WATER WELL RECORD (WWC5.2)

NIC: NMW-45DR Replacement Well Location; Former El Paso Refinery Site

Subject: Approval of Variance for Direct-Push Small Diameter Monitoring Wells. North Industrial Corridor (NIC) Site (KDHE Project Code C2-087-70150). Located in SE, Sec. 4, T. 27S, R.1E, Wichita, SG County, KS.

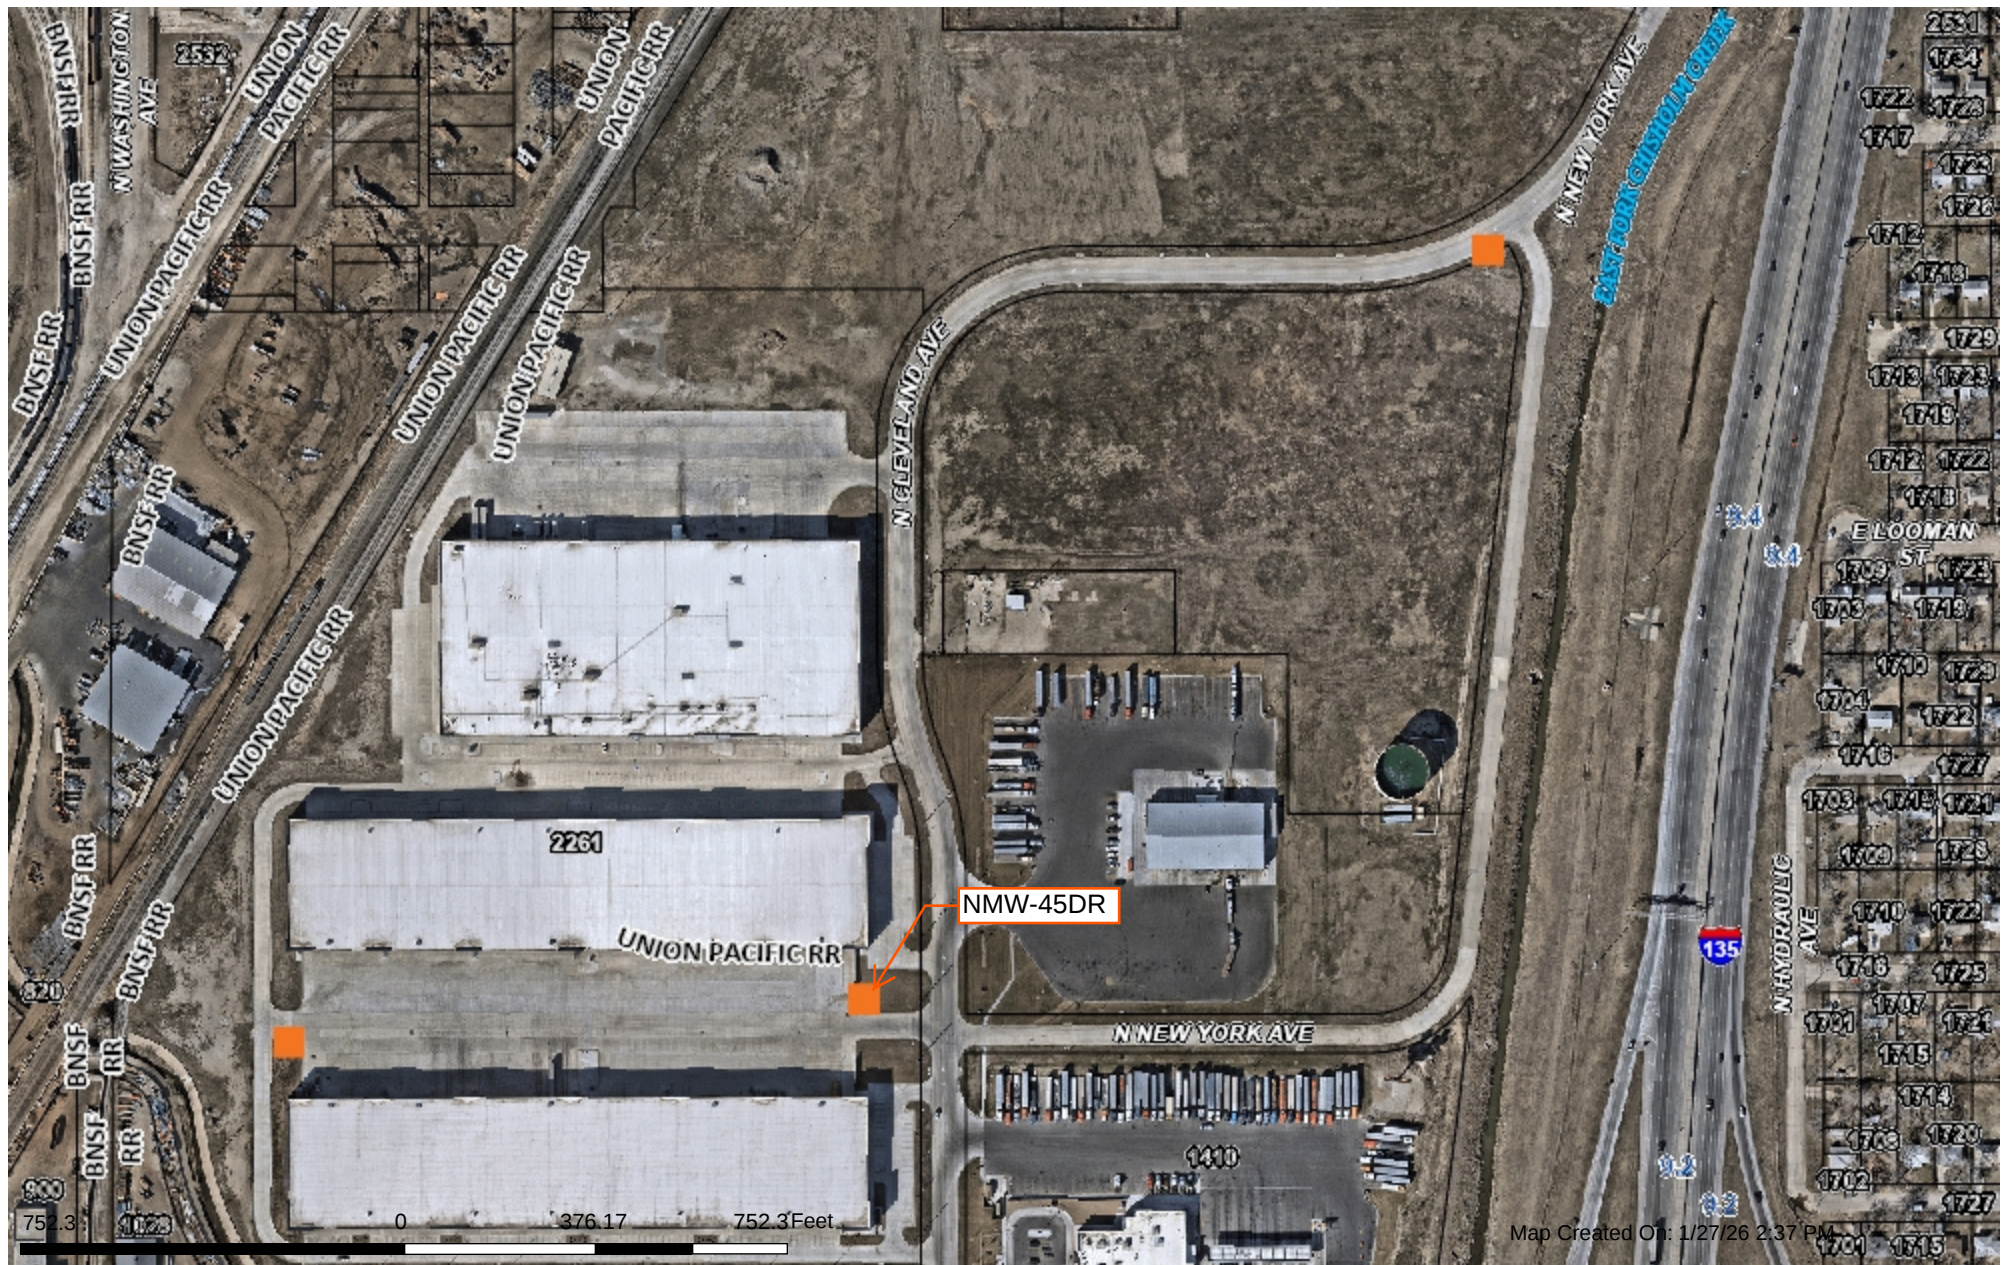
On May 4, 2026, the Kansas Department of Health & Environment, Bureau of Water, Geology & Well Technology Unit, Water Well Program (KDHE), received your variance request to construct three (3) flush-mount, small diameter monitoring wells using direct-push technology (DPT), at the above referenced area under contract with the City of Wichita. The request is to replace three (3) monitoring wells (NMWs 43DR2, 44DR, and 45DR) at the Former El Paso Refinery Site, all to be constructed with less than the required minimum annular space as per K.A.R. 28-30-6(b)(2).

KDHE considers the method of construction described in the request, and method of grouting as proposed in and approved for previous Below Ground Surface variance requests at this site to be adequate.

This letter provides notice of approval to construct three (3) small diameter monitoring wells within the subject area described above. Please comply with KDHE regulations in K.A.R. 28-30-6(s) for flush-mount well completion.
